SERVICE BULLETIN

APPLICABILITY: 2014-22MY Forester
 2013-21MY Crosstrek
 2015-21MY WRX

NUMBER: 05-88-21

SUBJECT: Front Stabilizer Bushing- Design Change
 Knocking / Squeaking Sound

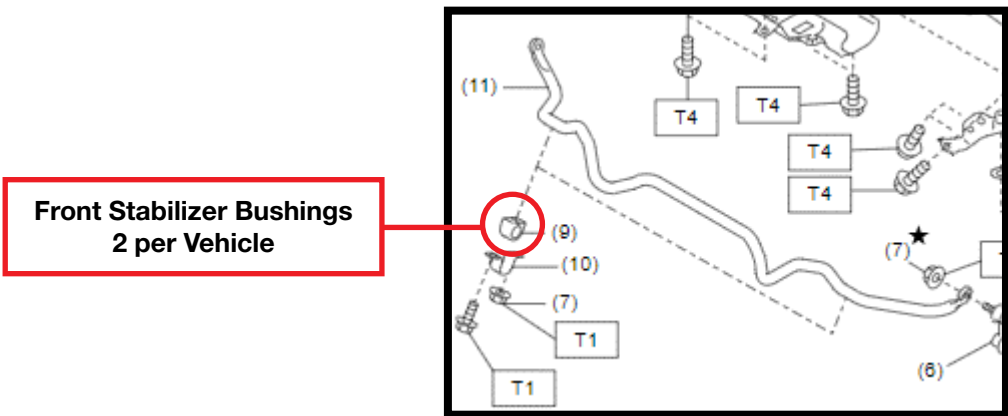
This bulletin announces a design change made to the front stabilizer bushings. The bushing material has been enhanced to address knocking / squeaking sounds when driving on rough roads during low ambient temperatures. If confirmed under the described driving conditions, the bushings shown in the illustration below should be replaced.

The new front stabilizer bushings have been incorporated into production as per the table below:

Model	Starting VIN
Crosstrek	MH385137
Forester	NH400041
WRX	M9816765

Part Description	Part Number
BUSHING-STABILIZER	20414SG001
